Access Compliance Report

Public Rights-of-Way

Intersection ID: N/A	Main Street: SHARON_AMITY_RD	Cross Street: N/A	Location: SW
ADA ID: 59FBFD7EDDFF	Ramp Type: PerpDiag	Initial Pass/Fail: Fail	Overall Compliance: No
Codes/Mitigation Info/Possible Solution		Field Measurements/Component Compliance

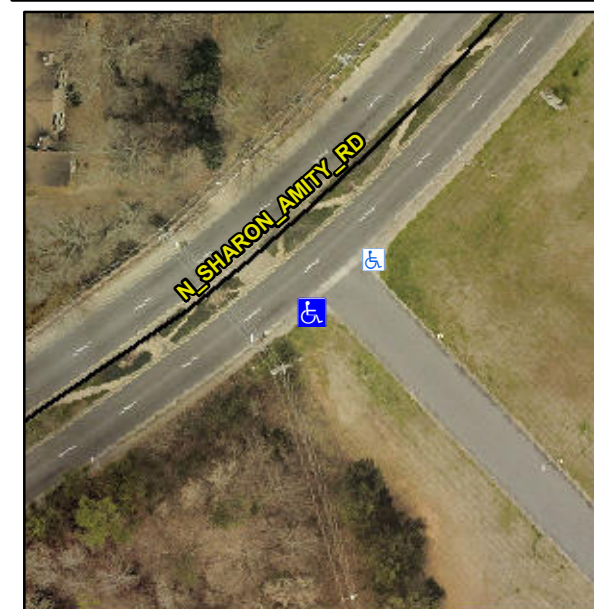
Not Found, R304.2.2, R304.5.3

Compliance	Description	Data	Compliance	Description	Data
N/A	Ramp Length (in)	61.0	No	Ramp Slope (%)	9.0
Yes	Ramp Width (in)	48.0	No	Ramp XSlope (%)	3.0
N/A	Flare Type LT	N/A	N/A	Flare Type RT	N/A
N/A	Flare Slope LT (%)	N/A	N/A	Flare Slope RT (%)	N/A
N/A	Flare Traversable LT?	N/A	N/A	Flare Traversable RT?	N/A
N/A	Landing Length (in)	N/A	N/A	DWS Provided?	N/A
N/A	Landing Width (in)	N/A	N/A	DWS Contrast?	N/A
N/A	Landing Slope (%)	N/A	N/A	DWS Length (in)	N/A
N/A	Landing X Slope (%)	N/A	N/A	DWS Full Width?	N/A
N/A	Landing Curb? (Y/N)	N/A	N/A	DWS Offset (in)	N/A
N/A	Shared Landing?	N/A			
N/A	Gutter Ponding?	N/A	N/A	Gutter Slope (%)	N/A
N/A	Gutter Lip Ht (in)	N/A	N/A	Gutter X Slope (%)	N/A
N/A	Painted X Walk1?	No	N/A	Painted X Walk2?	No
	X Walk 1 Direction	To NE		X Walk 2 Direction	To N
N/A	X Walk 1 Width (in)	N/A	N/A	X Walk 2 Width (in)	N/A
	X Walk 1 Slope (%)	2.9		X Walk 2 Slope (%)	0.1
	X Walk 1 X Slope (%)	4.9		X Walk 2 X Slope (%)	0.4

Remove & Replace Curb Ramp With Two New Directional Ramps or Equivalent.
